OSM/IN DECISION

Standard: EN 60670-1:2005	Sub clause: 12.1.2.4	Sheet N°: OSM/IN 233
Subject: Definition of “reverse tapers”	Key words: Reverse tapers	Meeting N°: 18 Item: 9.2

Cover plate with reverse taper

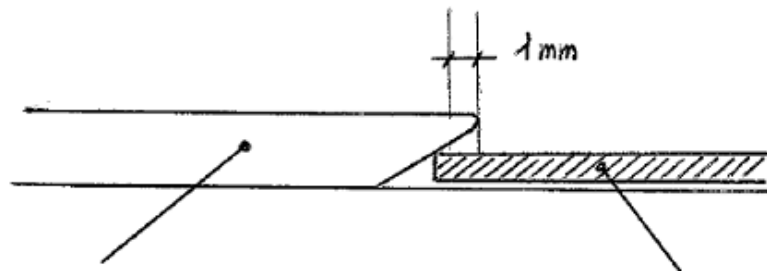
Question: The term “reverse tapers” is not clear.

In this case the test according to sub-clause 12.1.2.4 failed as the gauge enters more than 1 mm from the upper part of the reverse taper.

Decision: A representative drawing, in addition to Figure 17, regarding the application of the gauge of Figure 16 is given below.
